Responses to Reviewer 3 Comments

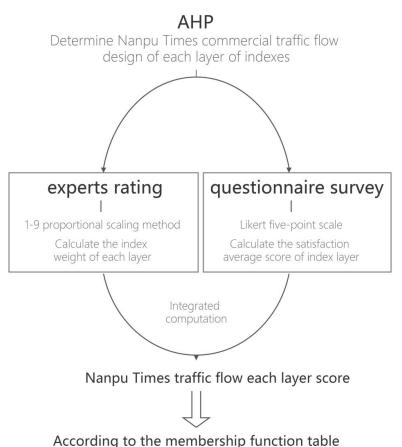
Point 28: Methodology: Additionally, the mixed methods of POE and AHP is currently not clear and would need significant clarification on how they worked together - I have an understanding but it is not immediately clear. For example, what was in the POE questionnaire - show an example of the questions or include the full questionnaire as a supplemental. How did the questions inform the AHP criteria selection? It is written but not easy to understand.

Response 28: In this study, POE was used to evaluate the traffic flow design of Nampu Times, in which the AHP method was applied. In the first step, the satisfaction evaluation system is determined through expert interviews and literature references. In the second step, the index weights of each layer were calculated through expert interviews using the 1-9 scale method. In the third step, the mean satisfaction score of the index layer was calculated by using a 5-point Likert scale through a questionnaire survey. In the fourth step, the index scores of each layer were calculated by combining the above two points. Finally, according to the membership function table for the Nanpu Times traffic flow satisfaction is evaluated and graded. This can be seen in the following visualization, i.e., Figure 4 in the study.
